## BALLANTYNE JSP13-43

Public hearing at the request of Singh Development for approval of Preliminary Site Plan, Site Condominium, Woodlands Permit, Wetlands Permit, and Stormwater Management Plan approval. The subject property is 50.85 acres in Section 31 of the City of Novi and located at the northwest corner of Garfield Road and Eight Mile Road. The applicant is proposing a 41 unit single-family site condominium development.

## PLANNING REVIEW

**SUBJECT: Ballantyne RUD, JSP13-0043, Traffic Review of Preliminary Site Plan, PSP14-0065**

**Eight Mile Road Frontage of Proposed Ballantyne RUD**

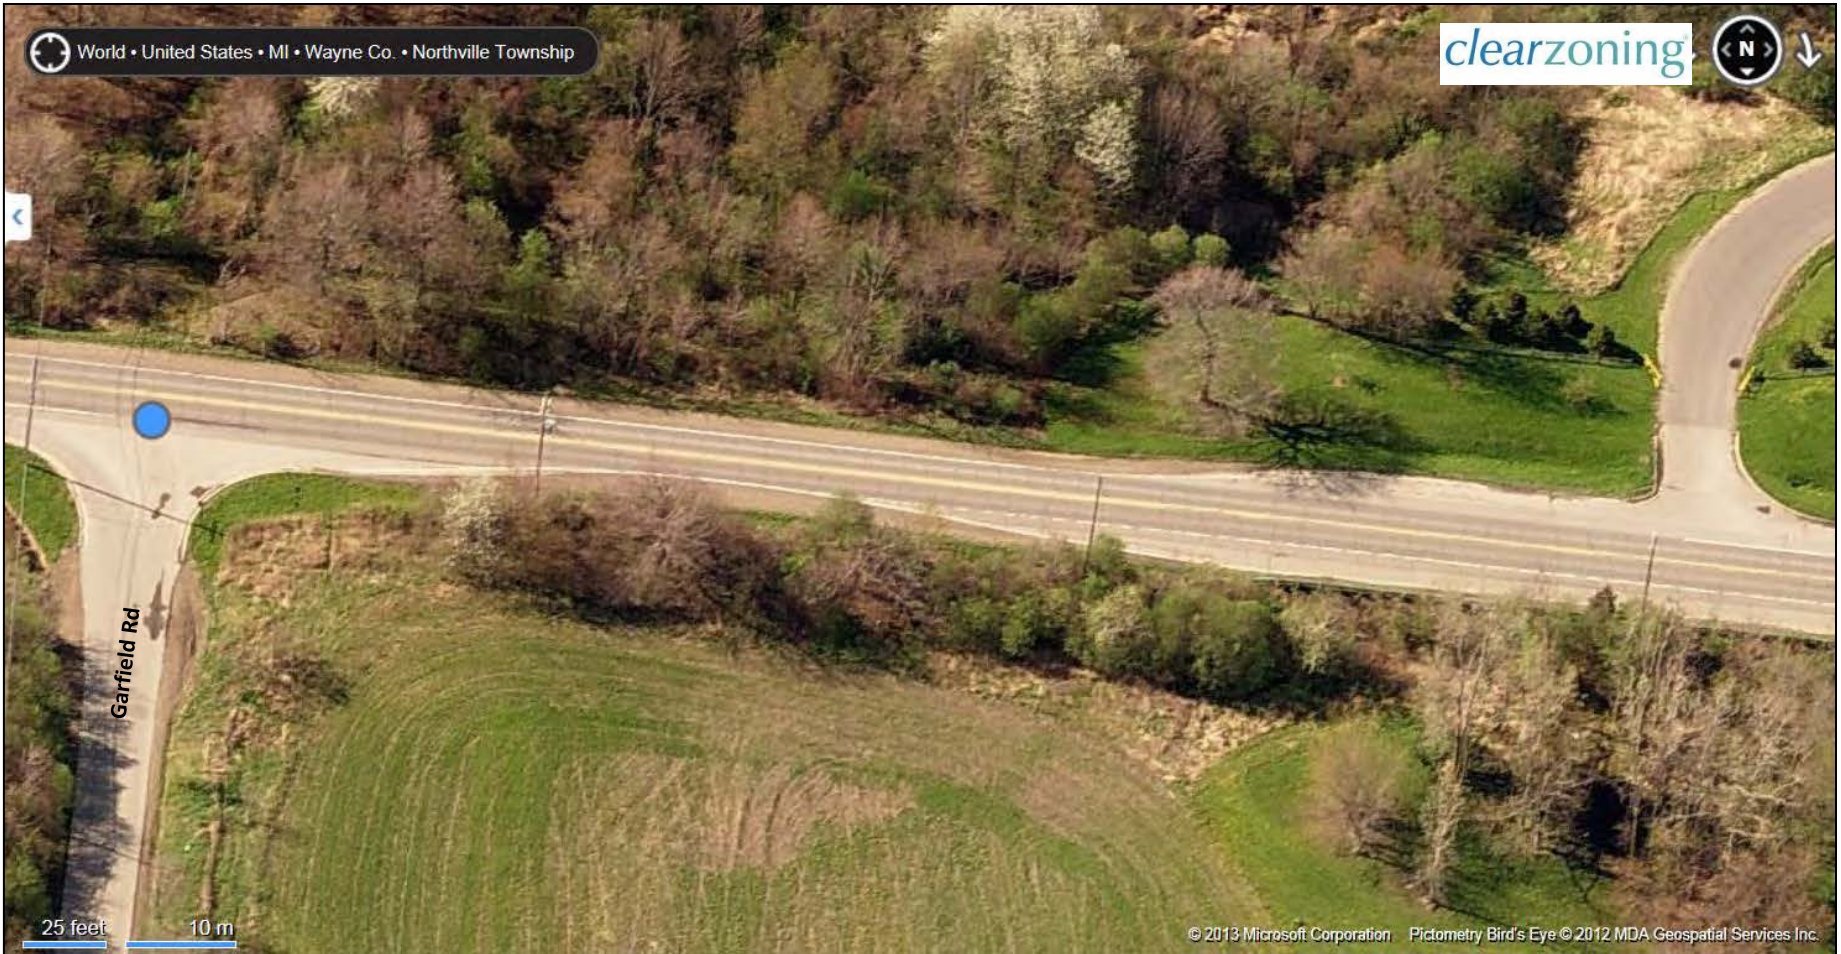
8. **The final site plan should include a larger-scale drawing of the site frontage along Eight Mile, showing a 4-inch solid white line separating the eastbound right-turn-only lane from the adjacent through lane, along with a RIGHT LANE MUST TURN RIGHT (R3-7R) sign midway along the accel/decel lane between Garfield and the site entrance.**

Figure 1. City of Novi Regulated Woodlands & Wetlands Map (accessed May 19, 2014).

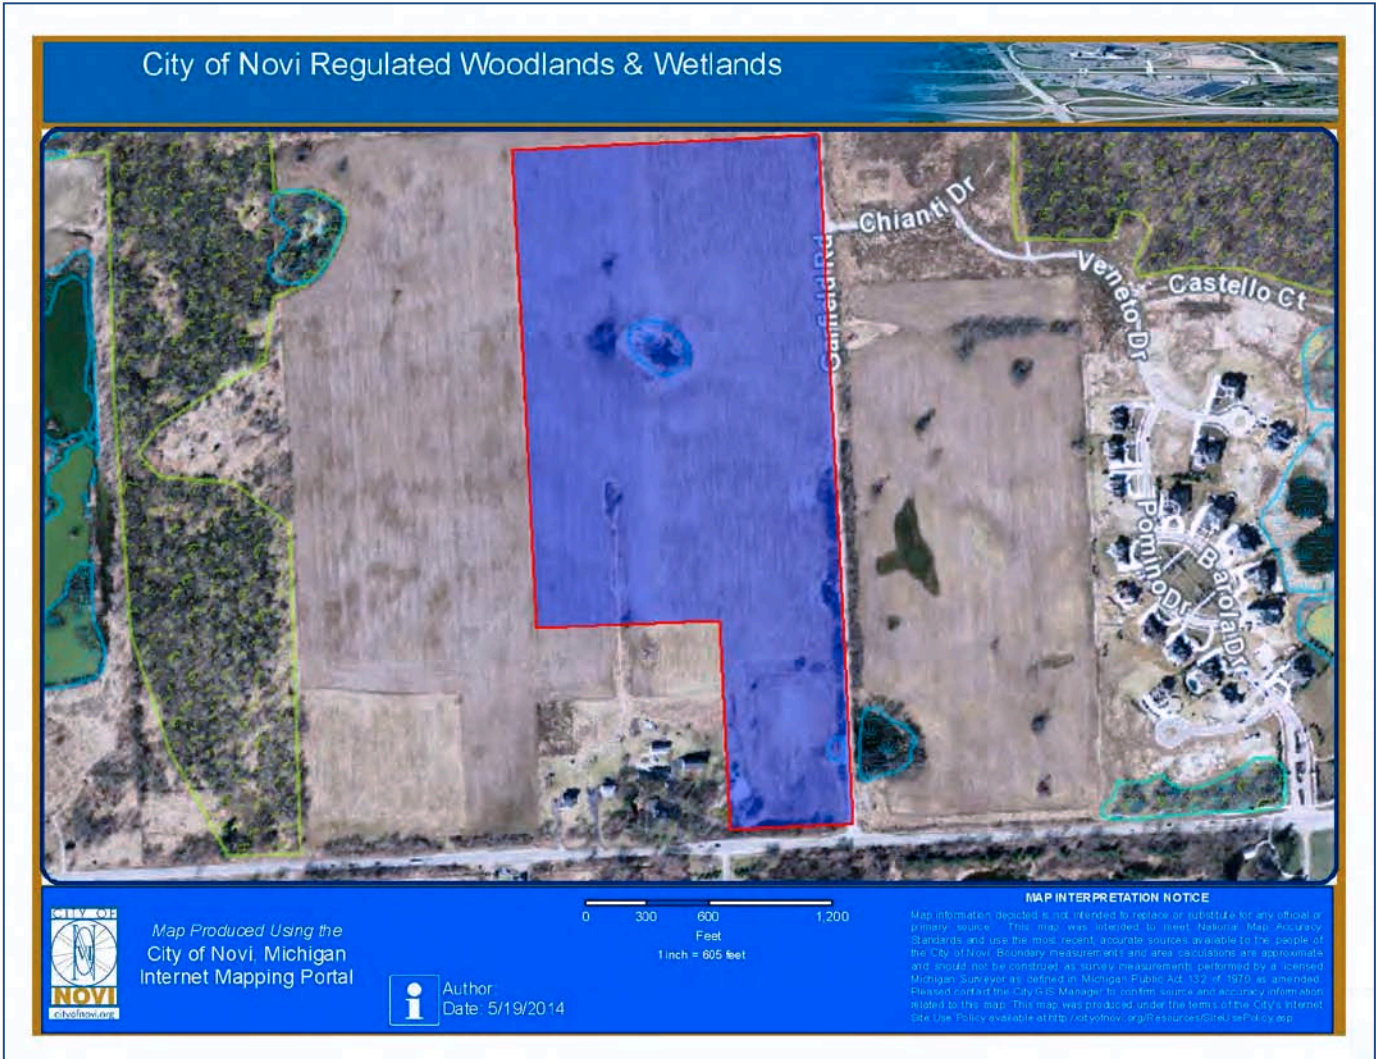
Based on our review of the Plan, Novi aerial photos, Novi GIS, and the City of Novi Official Wetlands Map, it appears as if this proposed project site contains several areas of wetland. The largest of the wetland areas (Wetland A) is located in the north central section of the site. The Plan indicates that this wetland is 0.75 acres (see Photo 1) and was delineated by Wilson Road Group. This wetland is an emergent wetland surrounded by shrubby vegetation as well as several American elm trees on the east side. The current Plan appears to propose preservation of this wetland within a proposed open space (Ballantyne Park). Although wetland boundary flagging was not readily apparent at the time of our site inspection, the wetland boundary appears to be accurately depicted on the Plan.
